Improved Transcoding Scheme for 40GBASE-T

Addressing Comment #403 to Draft 2.0

IEEE P802.3bq, Task Force meeting, May 2015

Step-2: Reduce Latency

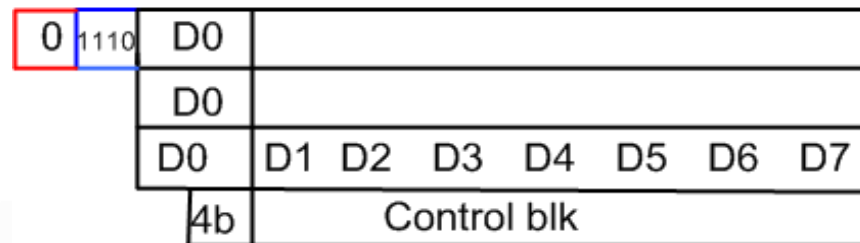
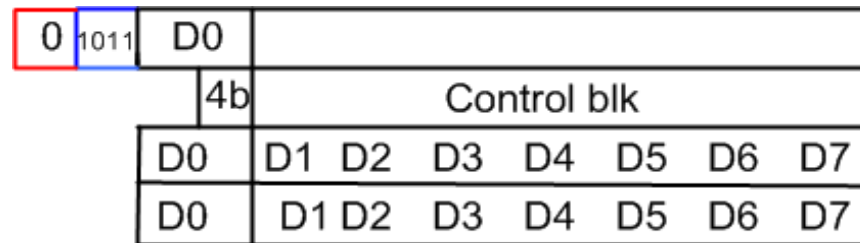
- To reduce processing latency, we transmit the first bytes of every 64-b blocks before sending out the rest 7 bytes of any 64-b block [2].
- In this way, the trans-decoding operation doesn't need to wait until the whole transcoded block of data is received.

Transcoding of Data Blocks

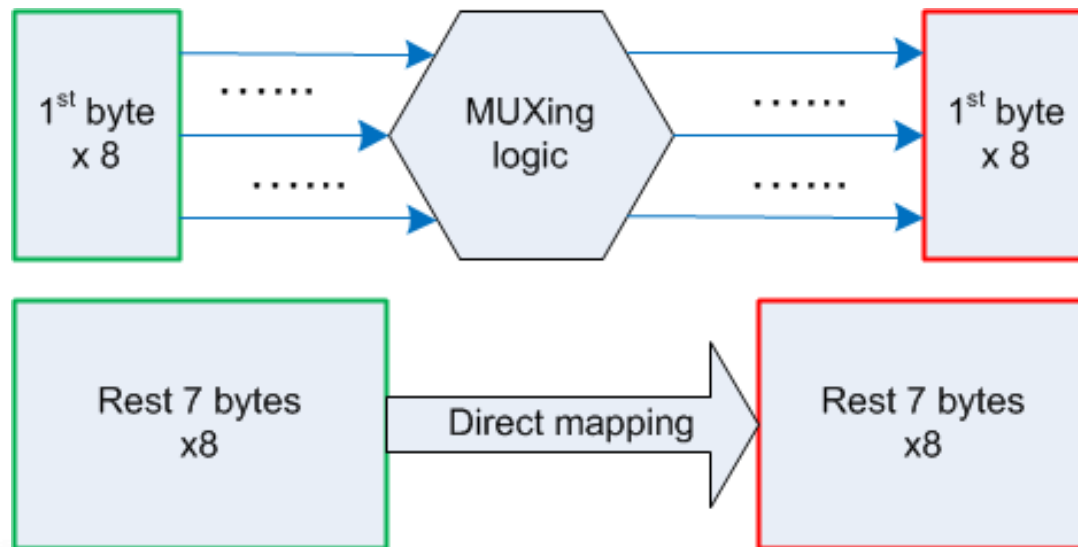
- When dealing with 8 65-b pure data blocks, to ease the implementation, we should first transmit the first byte of each 64-b block as we did for those cases with one or more control blocks.
- In this way, there are **fixed mapping locations** for each 64-bit block except the first byte.
